# FORD PERFORMANCE

## Technical Service Bulletin – 37a

### Mustang Dark Horse R ABS Updates

## Action 3: ABS Calibration

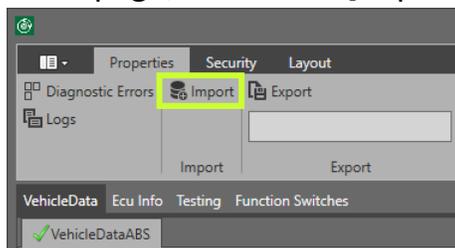
- Open RaceABS and connect to vehicle
- Navigate to the 'ECU Info' page, and verify that:
  - *FordDHR\_v02* is stated in the 'App Name' box

- If *FordDHR\_v02* is not stated in the 'App Name' box, navigate to the 'Vehicle Data' page, and select [import] in the top left of the page.

[must have Software Version 08.03.00.00.00.00]

- Navigate to and select this file:  
'RaceAbs.Export\_FordDHR\_v02\_BL08.03.abs'

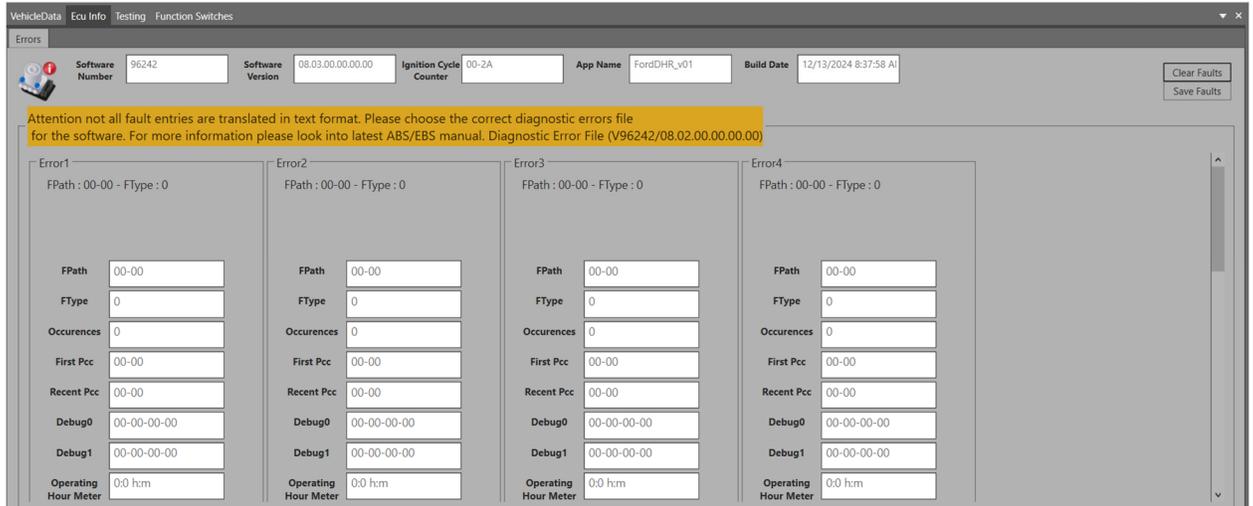
If software version 08.00.00.00.00.00 is present – a different calibration file is required.

- Follow the procedure above, but using calibration file  
'RaceAbs.Export\_FordDHR\_v02\_BL08.00.abs'

## Action 4: Verify the DTC Code definitions and RaceABS Software are properly linked

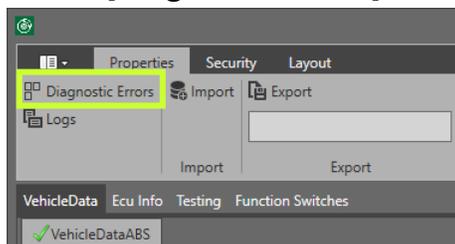
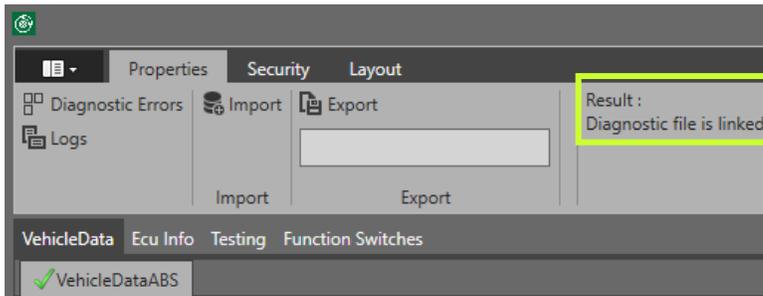
- Not having the proper DTC Code Definition .XML text file linked to RaceABS would make all DTC Codes meaningless
- Open RaceABS and connect to vehicle
- Navigate to 'Ecu Info'
  - If the incorrect DTC code Definition .XML is linked, the orange error statement below will occur:

- Select [Diagnostic Errors]

- Navigate to and select this file:
  - Patch: "C:\Program Files (x86)\Bosch Motorsport\RaceAbs\DiagFiles\UDS\08.03.00.00\TKWINX\_FAILUREMEMORYDESCRIPTION\_BB96242.XML"

- You should see "Result: Diagnostic file is linked"

- RaceABS is now linked to the proper DTC Code definitions file and the orange error will disappear. It's recommended to do a key cycle after this step
- The .XML text file may be opened to read the details and descriptions of ABS DTC Codes when trying to diagnose errors
